**Consumers
Power
Company**

Re: Docket 50-155
Regulatory Suppl File Cy.

Docket No. 50-155 Regulatory Suppl File Cy.

Answers to Additional Information Requested
Regarding Proposed Change No. 13

FIGURE 1. PEAK CLADDING TEMPERATURE FOR VARIOUS BUNDLES (L-O-C ACCIDENT)

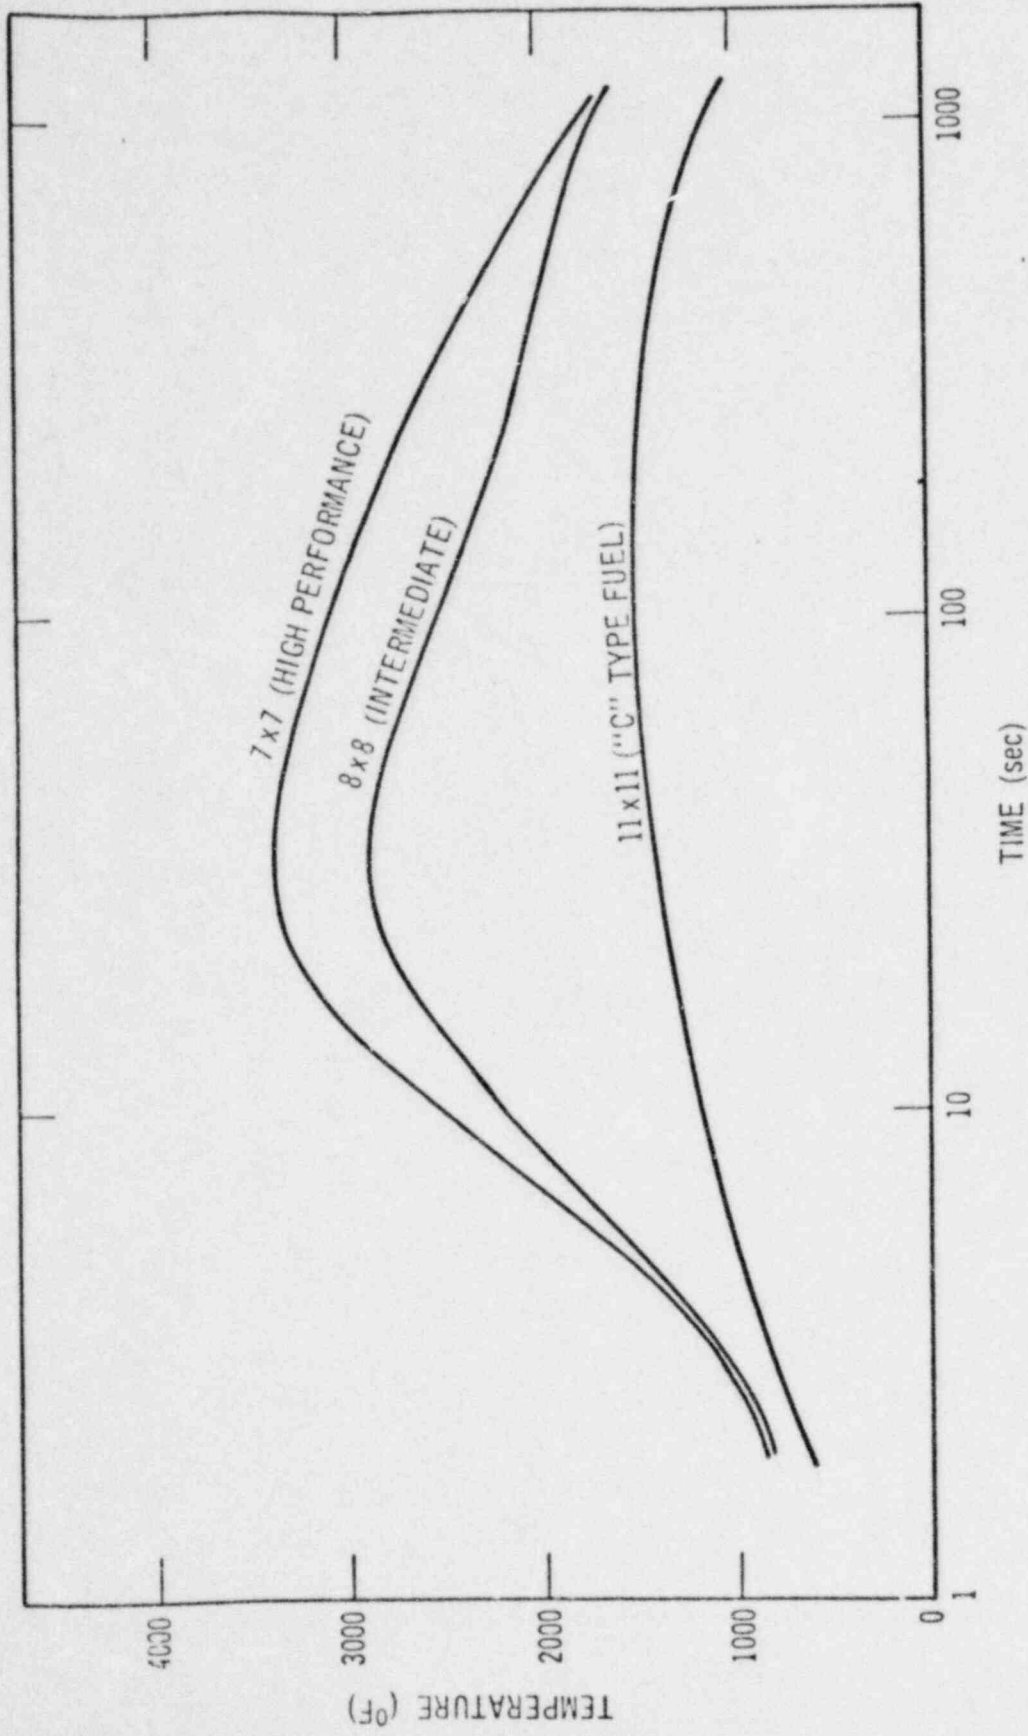
Question 2.1: Please discuss the analytical methods and input assumptions for determining peak fuel rod temperatures, and present comparative maximum temperatures for "C" and "centermelt" fuel rods after the MCA until the temperature rise has been arrested by fire main water sprayed onto the core via a single spray header inside the reactor vessel.

Comparative maximum clad temperatures calculated with this model for 7 x 7 high-performance, 8 x 8 intermediate, and 11 x 11 "C" -type fuel bundles are shown in Figure 1. The calculations show that the greater energy storage of the centermelt fuel results in higher peak temperatures than the bulk of the BRP bundles. Maximum (centerline) fuel temperatures are compared in Figure 2. Note the short time that centermelting remains after the accident.

FIGURE 3. MAXIMUM CLADDING TEMPERATURE FOR DIFFERENT DRYOUT TIMES

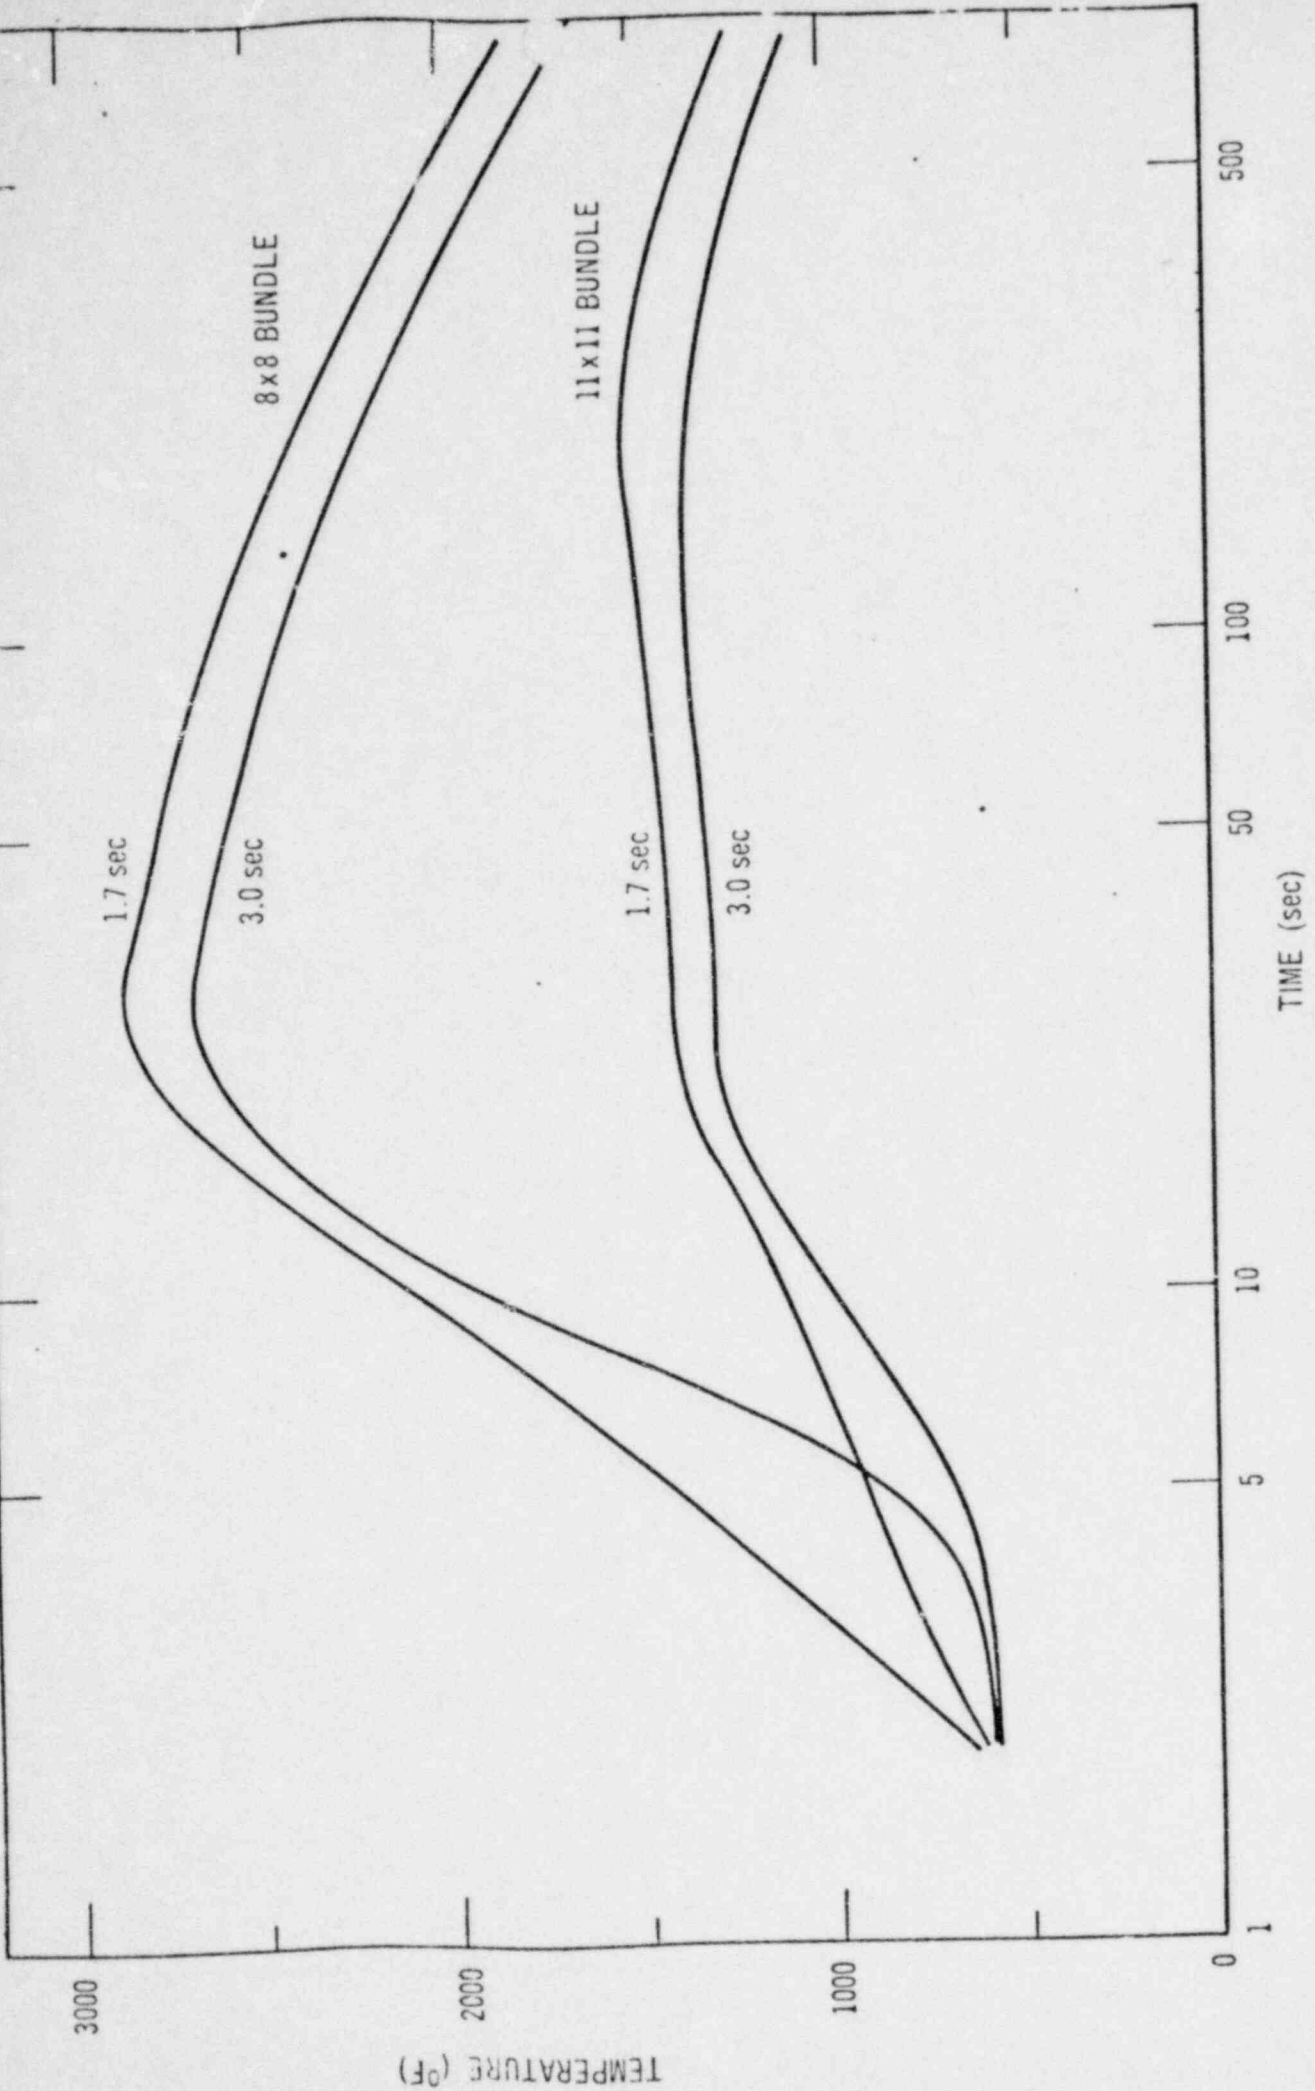
Question 2.2: Indicate the sensitivity of the fuel rod temperatures to duration of blowdown and core spray initiation delays.

Answer: Fuel rod temperatures show little sensitivity to dryout time (see Figure 3) or short term core spray initiation delays (see Figure 4).

FIGURE 5. SPRAY COOLING
EFFECT OF INITIAL TEMPERATURE

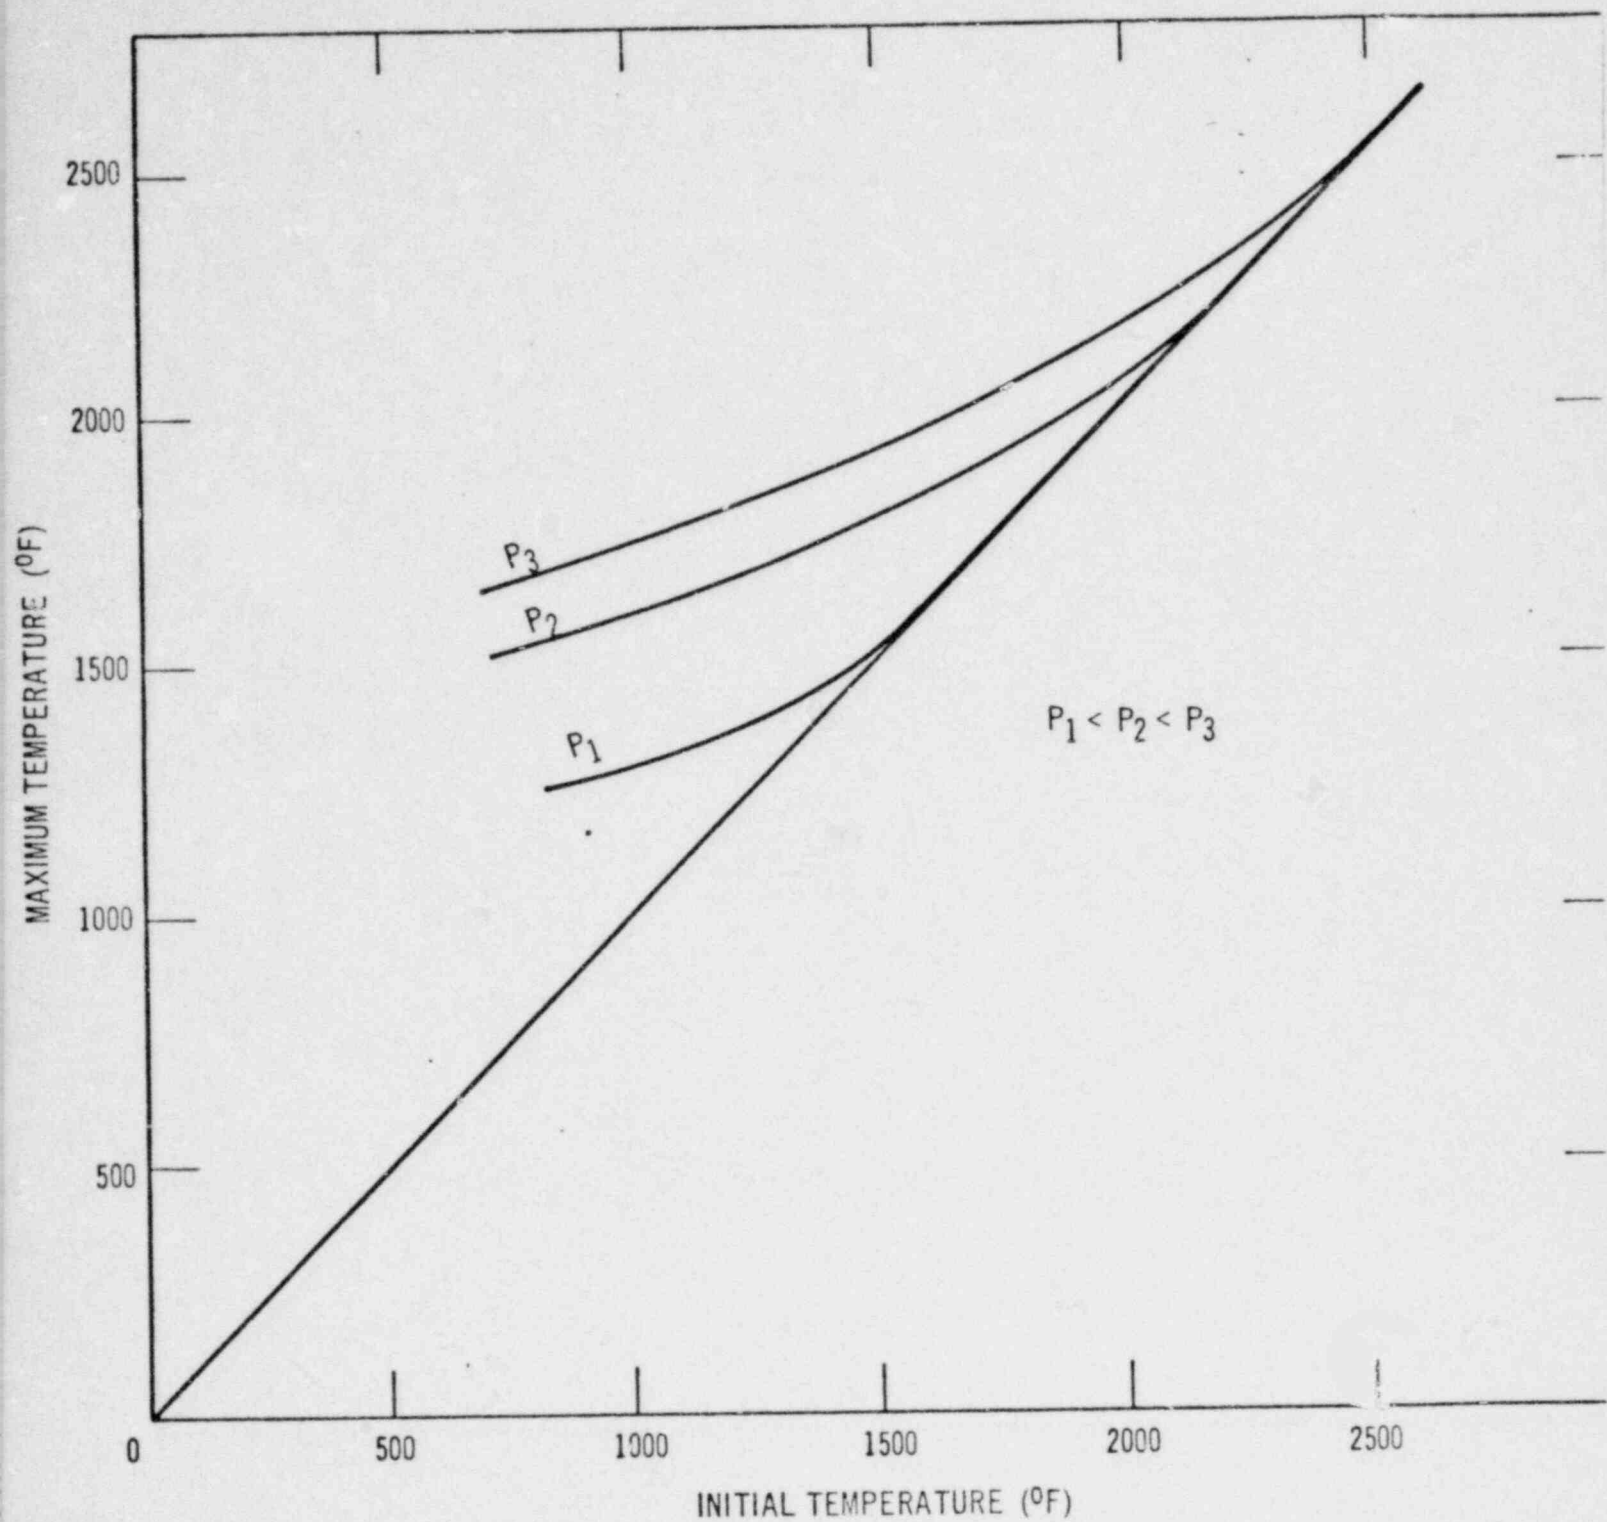
Question 2.3: Discuss the applicability of the test data presented in Figure 25 of the referenced proposal, which is based on initiation of core cooling (core spray) before fuel temperatures reach 1250°F.

The peak temperature predicted during a loss-of-coolant transient is a function of the bundle temperature at spray initiation. At a given power level, the magnitude of temperature rise (initial to peak) diminishes as the initial temperature is increased. This trend is shown by peak versus initial temperature relationships obtained in recent General Electric spray-cooling tests shown in Figure 5.

FIGURE 6. 9-ROD CHF TEST - LARGE RODS AND HIGH ROD-ROD PEAKING

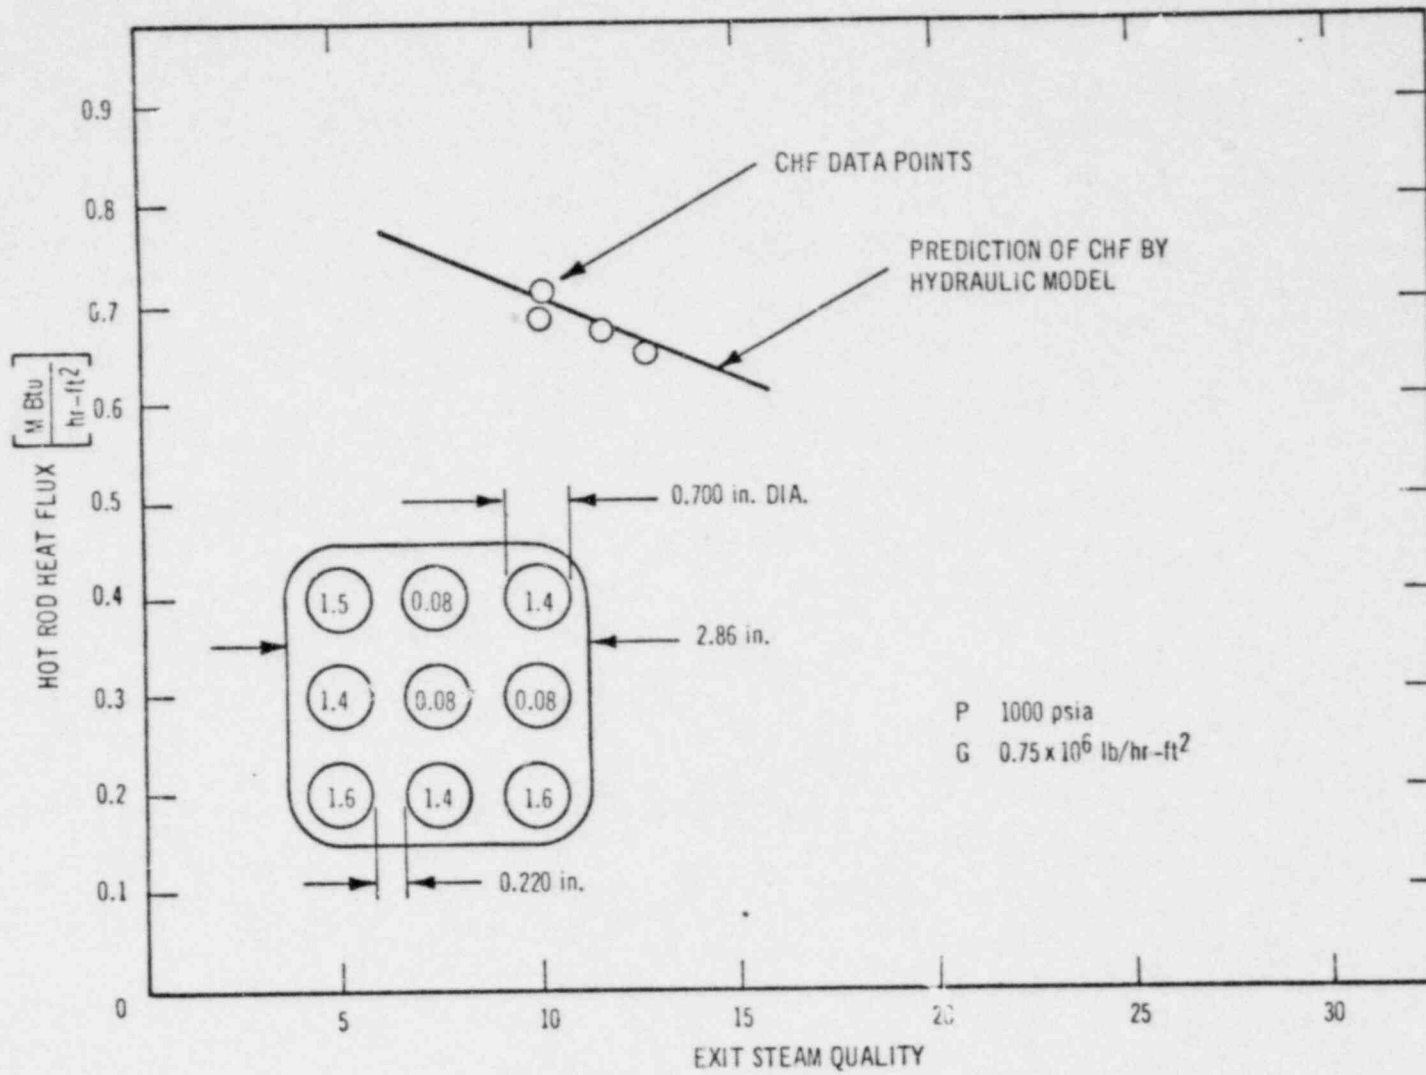
Please justify the use of the new GE Multi-Rod Critical Heat Flux Correlation in calculating "centermelt fuel" core performance limits, considering the spiked arrangement of the centermelt fuel rods within the bundles where power ratios of adjacent rods are approximately 18:1 in contrast to the normal situation where adjacent fuel rod power ratios are near to 1.

correction factor was determined by applying the Multi-channel Model to the centermelt bundles. The applicability of the Multi-channel Model to test sections with severe rod-to-rod peaking and slightly larger rods was ascertained by conducting special critical heat flux tests in such a nine-rod test section and comparing the model predictions to the test results. The agreement between Multi-channel Model prediction and the test data was excellent as shown on Figure 6.
